Central Sydney Planning Committee

Agenda

1. **Disclosures of Interest**
2. **Confirmation of Minutes**
3. **Matters Arising from the Minutes**
4. **Development Application: 262-266 Castlereagh Street and 271-279 Elizabeth Street, Sydney - D/2022/152**

5. **Development Application: 330 Botany Road, Alexandria - D/2021/1484**
6. **Post Exhibition - Planning Proposal - 118-130 Epsom Road and 905 South Dowling Street, Zetland - Sydney Local Environmental Plan 2012 and Sydney Development Control Plan 2012 Amendment**

Figure 16: Originally lodged scheme - Section

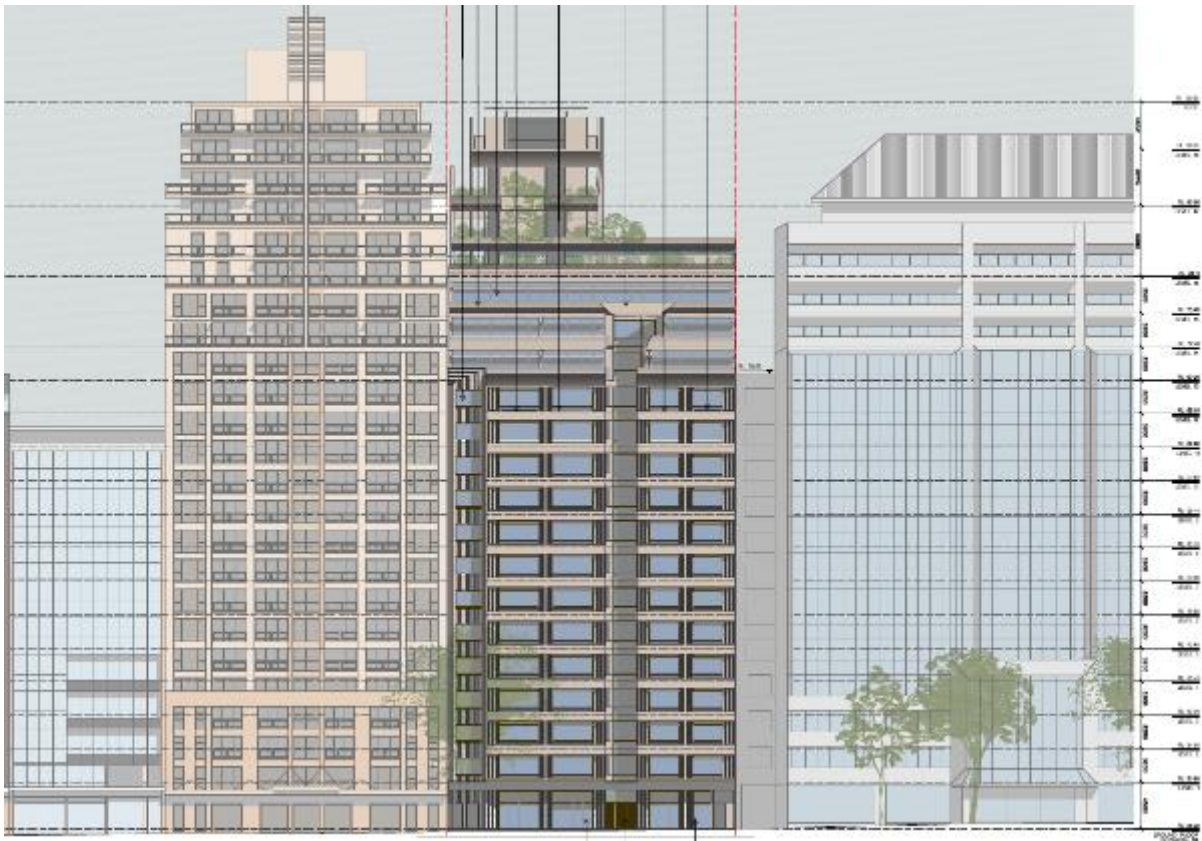
11. Key design issues discussed during the meeting are summarised below (other planning matters were also noted).
 - (a) The proposed roof top design (as illustrated in the section drawing in Figure 16 above) does not meet the requirements of Clause 5.6 of the Sydney LEP 2012 and as such, is not an architectural roof feature as defined under this clause. This clarification has impacts on the height of the development.

12. In response to the matters raised at the meeting, the applicant submitted additional documentation on 13 July 2022, as summarised below:
- (a) Wind tunnel effects within central void: The proposed awning at ground level on Elizabeth Street will protect pedestrians at ground level, and wind movements will become stagnant within the central void/light well causing no impact to the ground level or courtyard at the base.

- (c) An amended roof top design (see Figure 18 below) was provided, as well as a written response as to how the applicant was of the opinion that the roof design met the requirements for an architectural roof feature under the LEP.

Figure 49: Level 1 Floor Plan, communal areas shaded in red

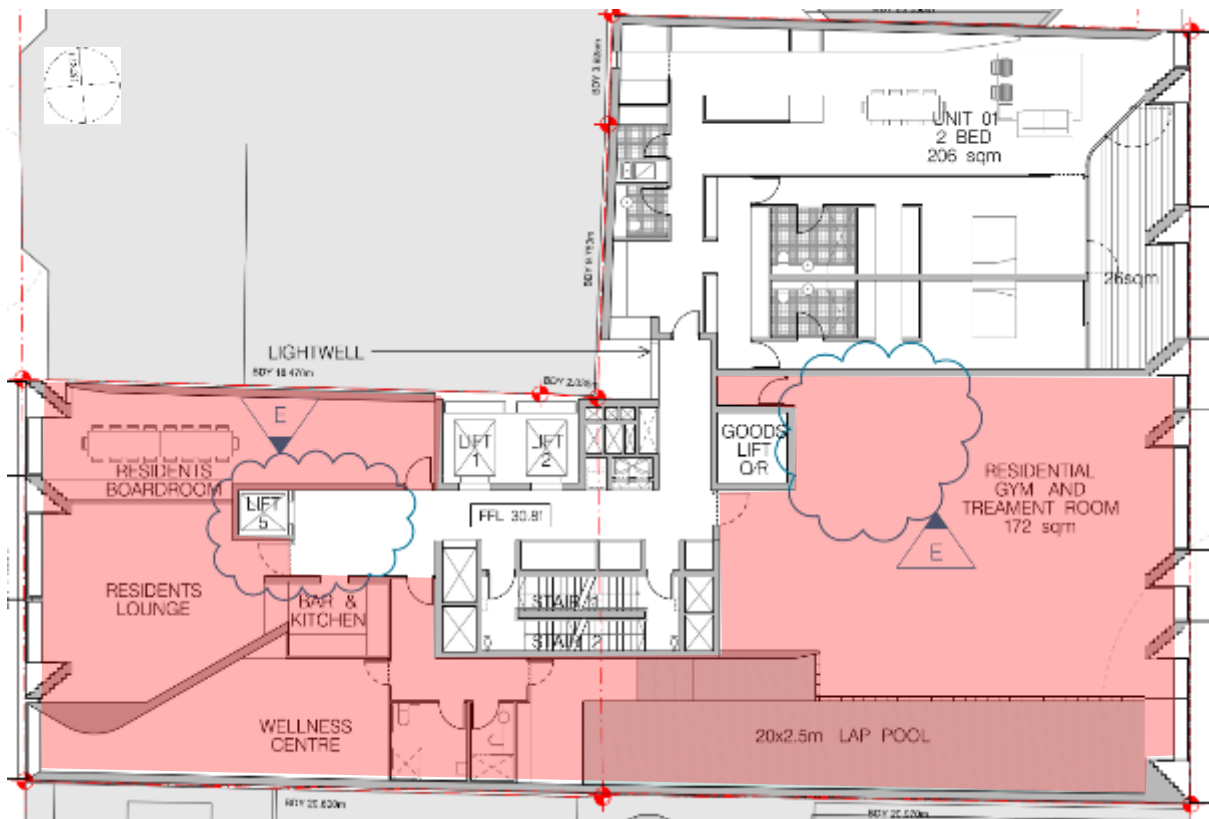
69. The proposed common rooms on Level 1 are considered to adequately provide for passive recreation as well as opportunities for social interaction of residents and is considered to contribute to residential amenity in a reasonable manner given its dense CBD context.
70. Further, in accordance with the design guidance outlined above, the proposed development includes increased private open space for apartments and is in close proximity being across the road from Hyde Park, Australia's oldest and most well-known public open space.

Figure 44: Typical detail of proposed attenuated natural ventilation plenum (source Natural Ventilation 330-332 Botany Road, Rev. C, 1 December 2022, Flux).

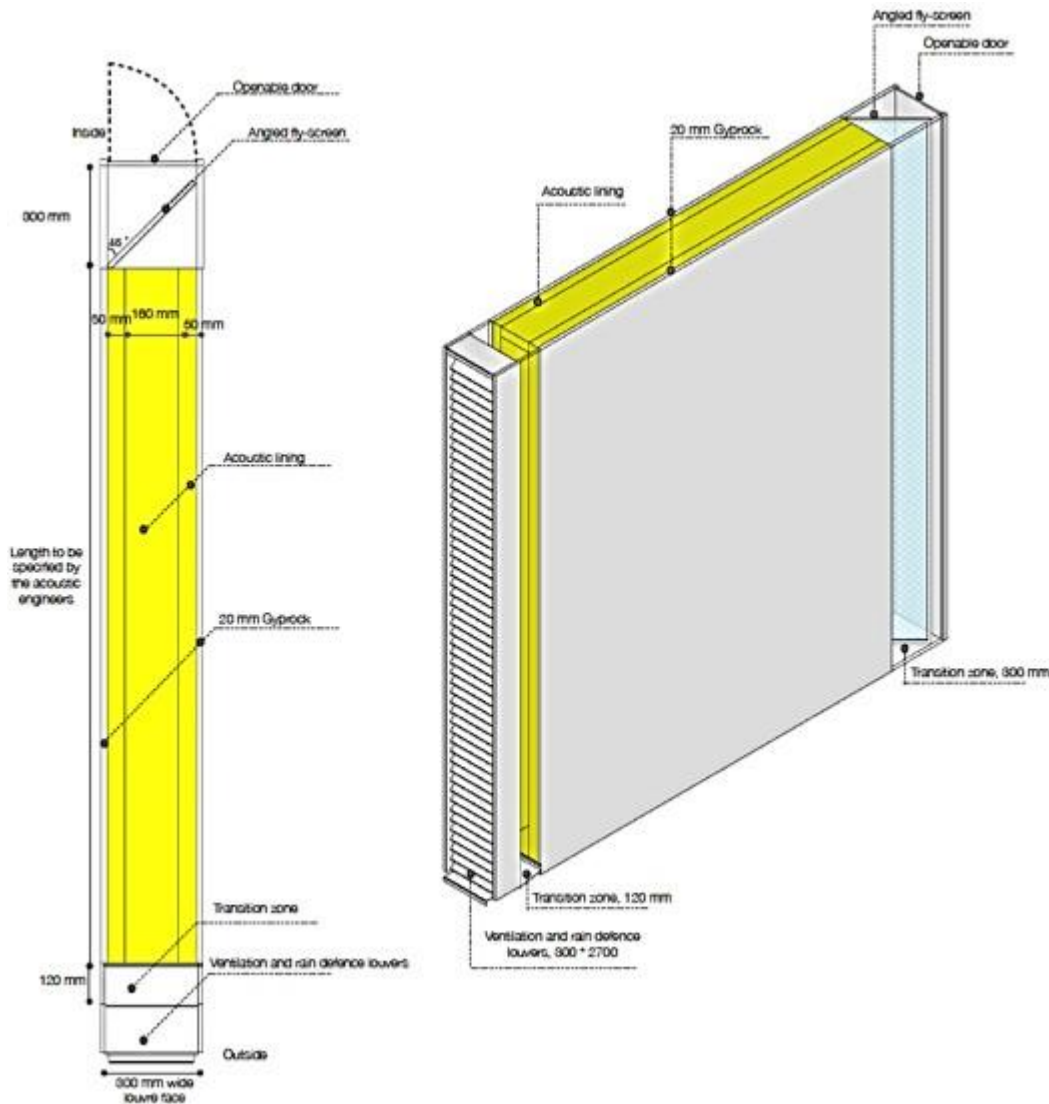
107. As shown in Figure 44 below, the Ventilation Report contains diagrams that illustrate the typical arrangement of a vertical plenum, excluding the structure. That is, it shows the 160mm clear plenum width, the 50mm acoustic linings and 20mm plasterboard to both sides of the plenum and which adds up to a width of 300mm in total. However, these diagrams and the spatial allowance within the reference scheme plans do not account for the outer structure and cladding of the plenums, particularly where they are located on an external wall.

Figure 45: Illustration of corner apartments that have been included in the applicant's tally of naturally cross ventilated apartments.

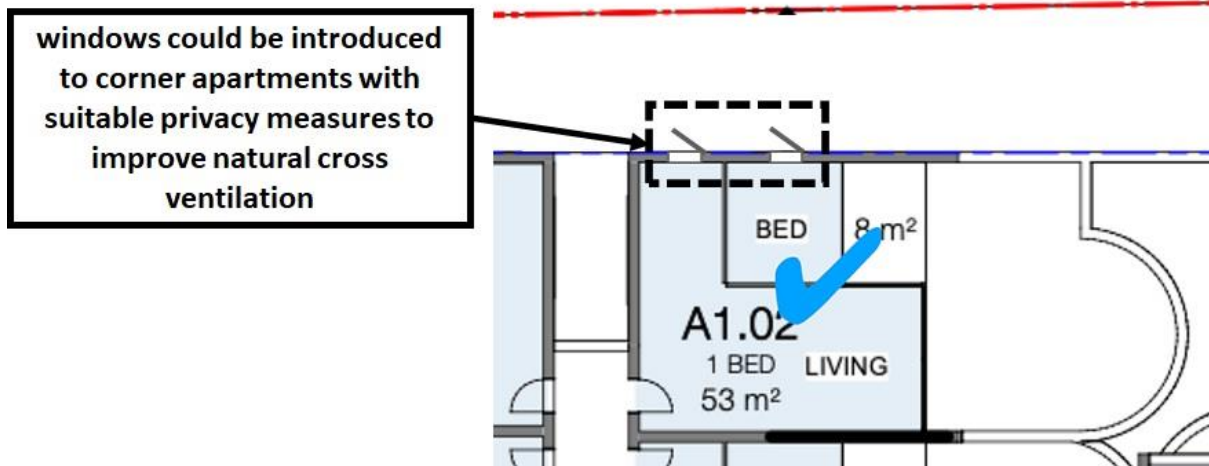
- 110. Forty-four percent (49 of 111) of non-noise affected apartments within the first nine-storeys of the reference scheme are naturally cross ventilated. This is counting the 8 apartments (AG.01 to A7.02) that are not naturally cross-ventilated, an example - apartment A1.02 - is shown in Figure 45 below, but which could easily incorporate a window in their northern elevations to be configured as corner, and therefore naturally cross ventilated, apartments.

111. The satisfaction of ADG objectives will need to be addressed through the competitive design process and subsequent detailed design DA by introducing windows as illustrated in Figure 45 below, as well as by introducing breaks in the building massing and which will likely result in a reduction in achievable development yield.

Figure 47: Recommended design modifications to accurately illustrate deep soil zones.

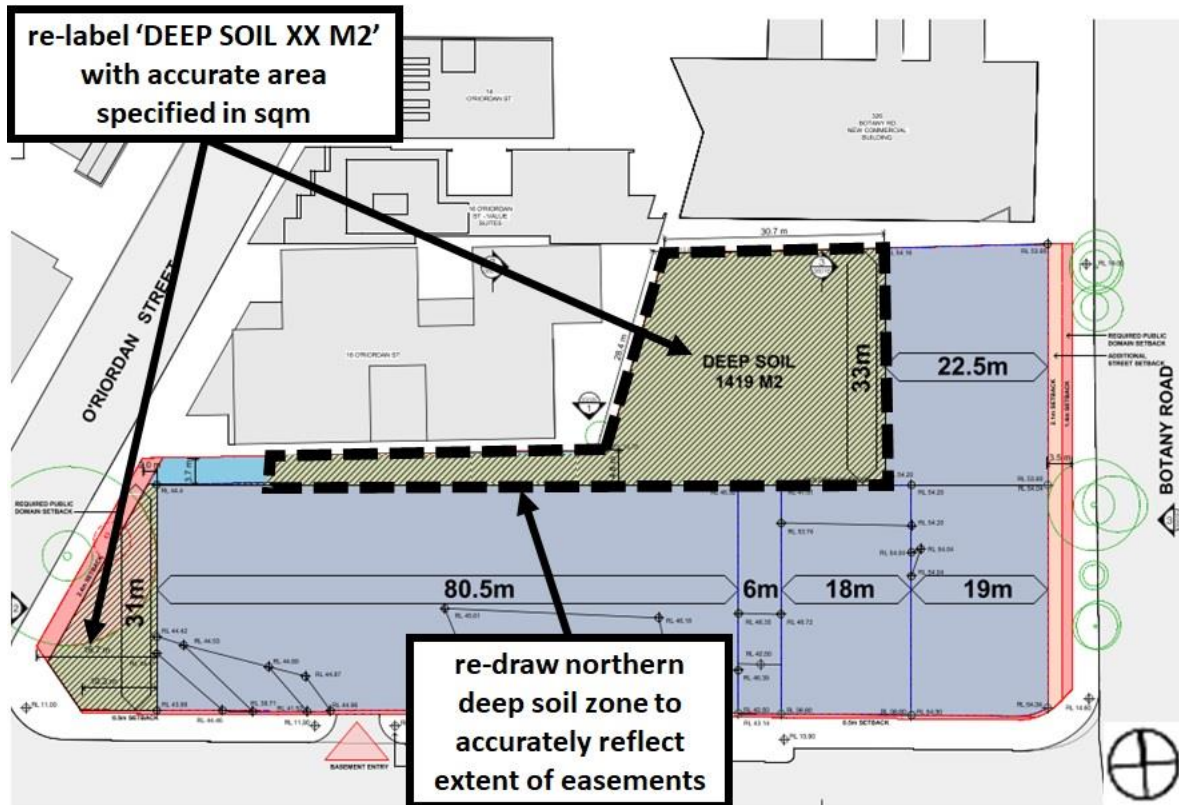
127. Conditions are recommended for the drawing titled Envelope - Site Plan (no. SK-0103E) to be amended as follows and as illustrated in Figure 47 below:

- (b) both of the deep soil zones are to be annotated as 'DEEP SOIL' and with the area of each deep soil zone specified in square metres;
 - (c) conditions are recommended for any structures in deep soil zones to be constructed of lightweight materials such as timber decking or water permeable paving to allow for filtration of rainwater into the ground.
